TXDOT and Development Accommodation Proposal

I-30 @ MacArthur

**TXDOT and Development Accommodation Proposal** I-30 @ MacArthur

TXDOT Accommodation Proposal
I-30 @ MacArthur

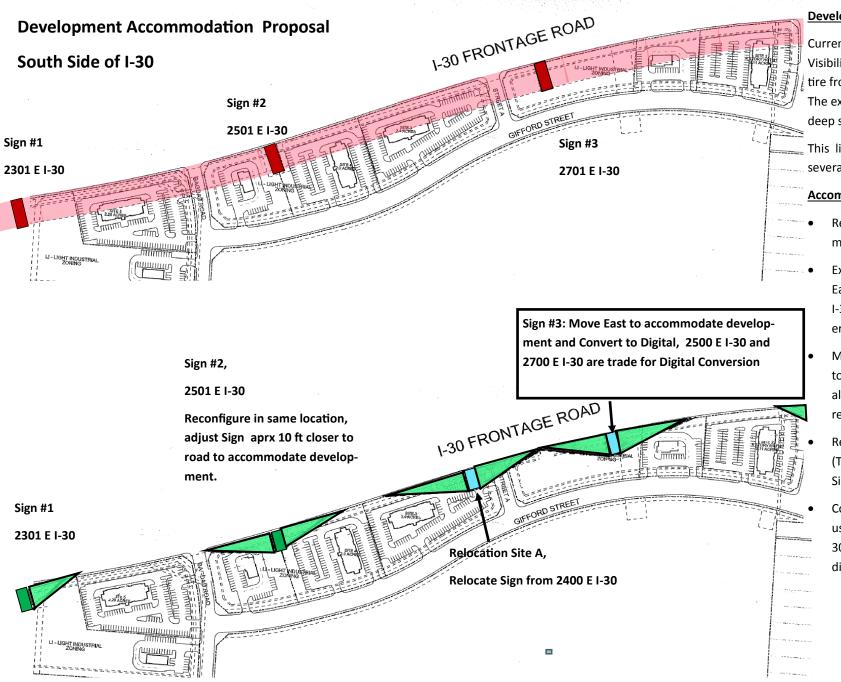
2400 E I-30: Relocate to South Side of I 30, relocation site A

2500 E I-30: Remove, digital conversion trade

2600 E I-30: Remove, digital conversion trade

2800 E I-30: Reconfigure, new height per TXDOT regulations, maximum of 42.5 ft above grade of I-30, no more than 75ft overall height.

2900 E I-30: Reconfigure, new height per TXDOT regulations, maximum of 42.5 ft above grade of I-30, no more than 75ft overall height.

2301 E I-30: No Change

2501 E I-30: Reconfigure 10-15 feet closer to Hwy to facilitate development of property. Same height

2701 E I-30: Move sign 245 ft east to facilitate development of property and convert to Digital, maximum overall height 55ft, meet all requirements of Article 9 Sign Standards, Section 8- Digital Billboards and Signs.
